TRUCK UTILITY MEDIUM (TUM) HS

MODIFICATION INSTRUCTION No. 13

SUBJECT: Fitting Glow plug timer interface harness

SUBJECT: Fire extinguisher

Fig 4 Extinguisher bracket (mounting) to LH seat base assembly

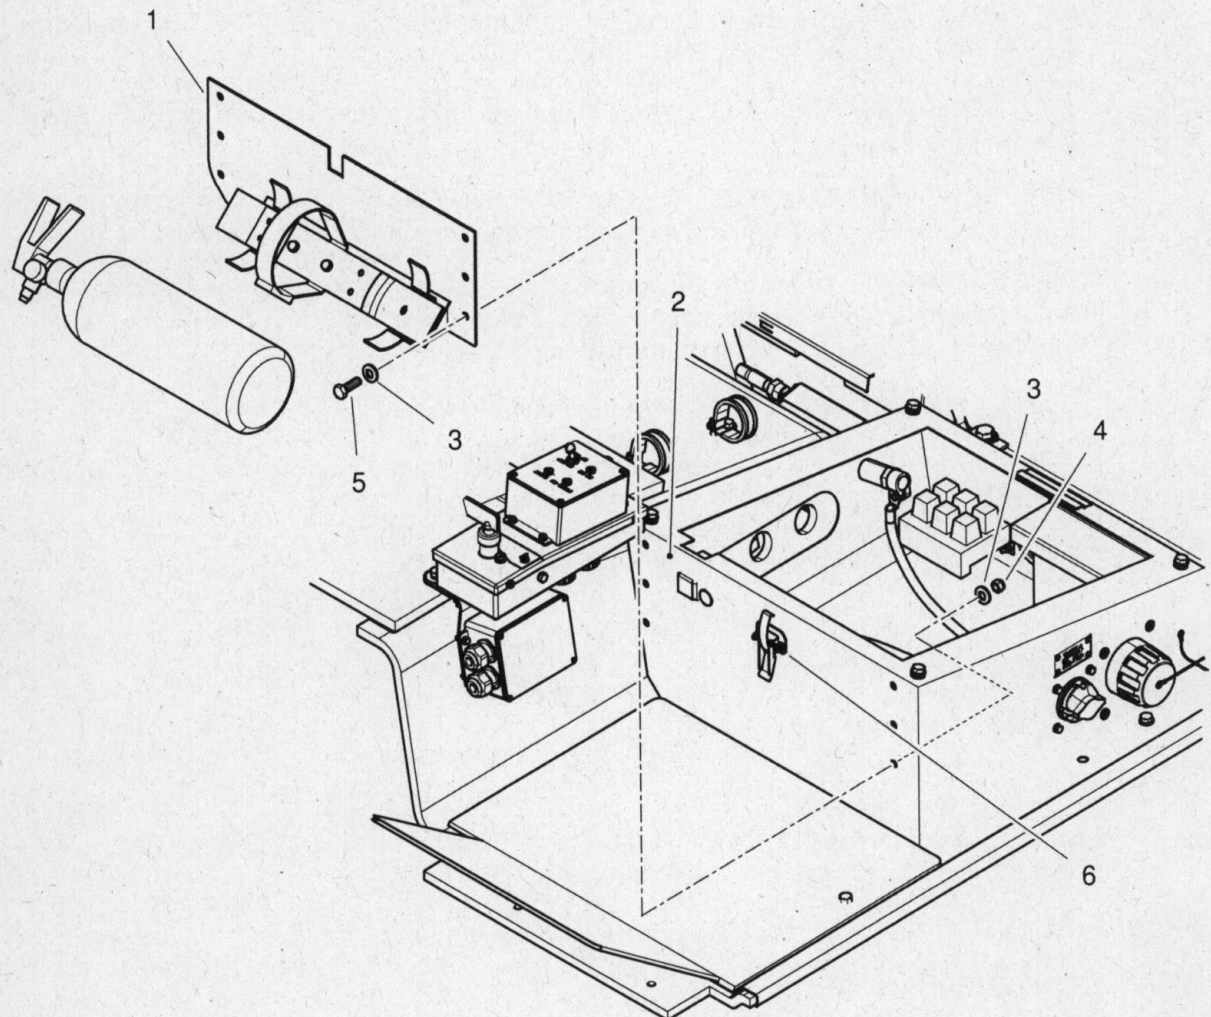
15 To fix the extinguisher bracket (mounting)(Fig 4(1)) to the LH seat base assembly (2) proceed as follows:

15.1 Using the extinguisher bracket (mounting) as a template mark out the six holes on the LH seat base assembly.

The extinguisher bracket (mounting) is designed with a cut away to clear the LH seat base assembly over-centre catch (6). If when aligning, the cut away will not clear the LH seat base assembly over-centre catch it may be necessary to cut out a section of the rubber floor mat to aid fitting.

15.2 Using a suitable drill and 8.5 mm drill bit, drill the six holes in the LH seat base assembly. Once drilled, removed any burrs from around the holes.

15.3 Secure the extinguisher bracket (mounting) to the LH seat base assembly using screws (5), washers (3) and nuts (4).
